SPA-QUIP

Notice To Customers

Controller Functionality Change

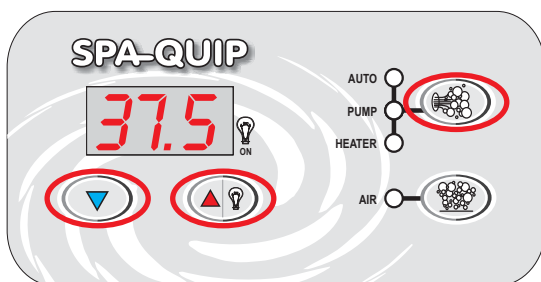
Due to recent changes in electrical safety standards, Spa-Quip controllers now behave differently in the event of a controller error condition. In the past when a controller has entered an error condition it has been possible to reset the controller by turning the power to the controller off then on again.

The controllers are now reset differently, in the event of an error condition the controller can now be reset by pushing a combination of touch pad buttons. The combination of buttons is different depending on the controller model.

Note: Resetting the mains power will not clear an error condition.

The Spa Power 601 controller is the first controller to be changed with all other controllers changing in the near future.

Special note: It is important to match your controller user guide to the controller in the spa, the changes to the reset procedure have been up dated to reflect this, but care will have to be taken not to mix up controllers and user guides. Any SP601 controller received with a serial number above SQG106L**339703** will be equipped with this reset method.

To reset the SP601 controller from an error condition simultaneously push the three circled buttons.
